ADDENDUM

Date Issued:	August 25, 2023
Project:	Intermountain Healthcare IMC- Angio Lab #3 Remodel 5121 South Cottonwood Street Murray, Utah 84107
Addendum Number:	1

Electrical Addendum

**LEVEL 1
 AUXILIARY
 PLAN**

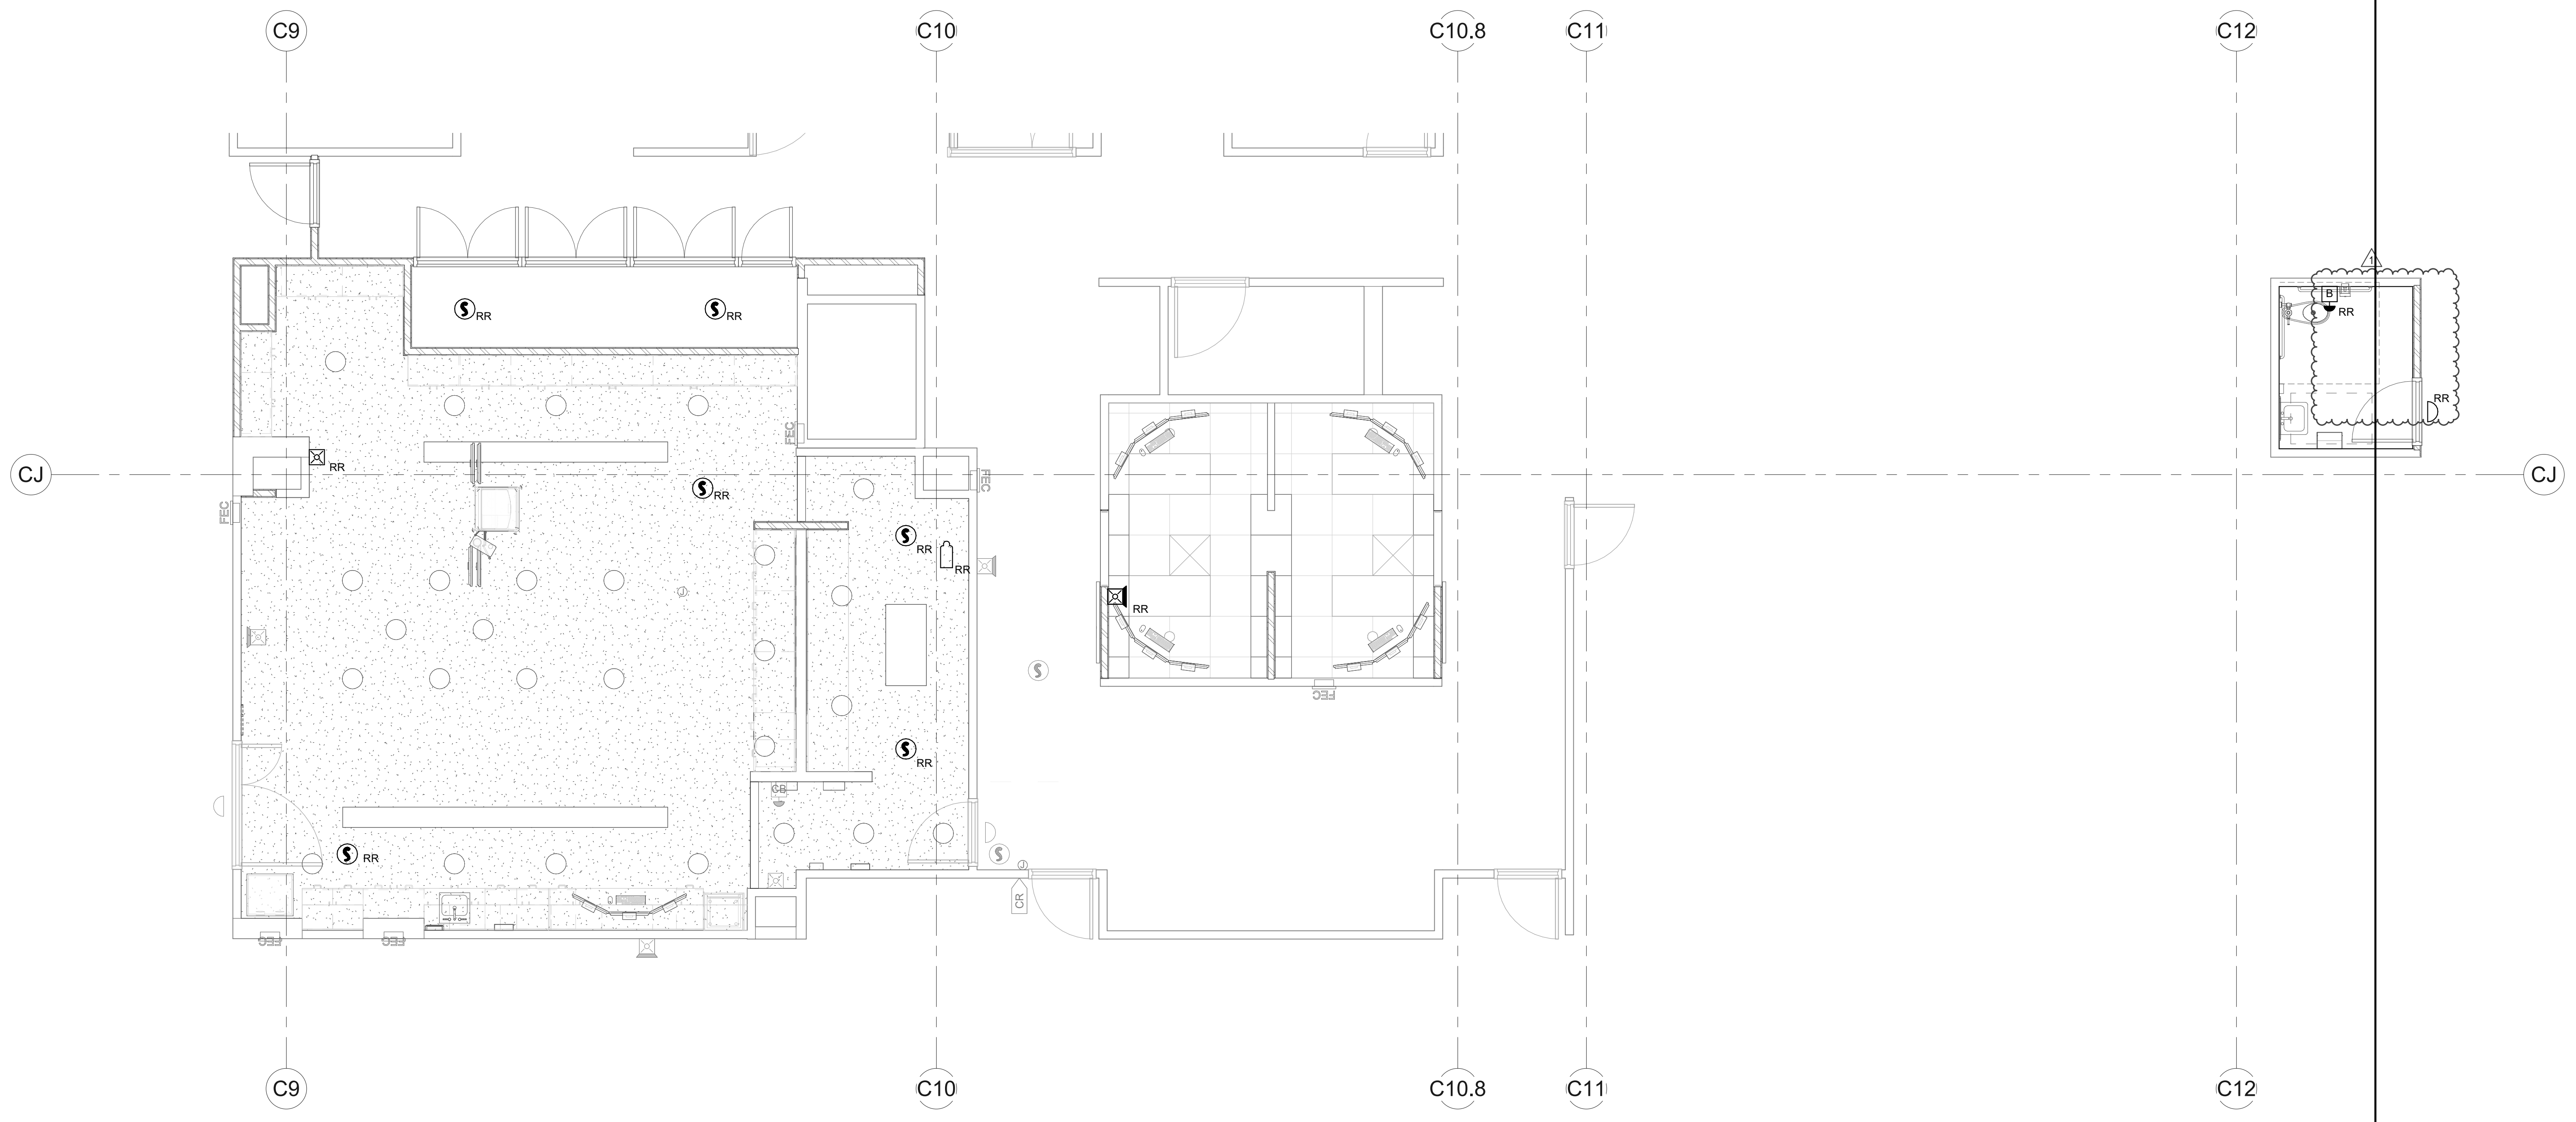
1. ED101 – Level 1 Electrical Demolition Plan
 - a. Showed nurse call pull station and dome light being relocated.
2. EP701 – Phillips Drawings
 - a. Updated to the latest Phillips drawings revision.
3. EP702 – Phillips Drawings
 - a. Updated to the latest Phillips drawings revision.
4. EP703 – Phillips Drawings
 - a. Updated to the latest Phillips drawings revision.
5. EP704 – Phillips Drawings
 - a. Updated to the latest Phillips drawings revision.
6. EY101 – Level Auxiliary Plan
 - a. Added relocated nurse call pull station and dome light to new restroom.
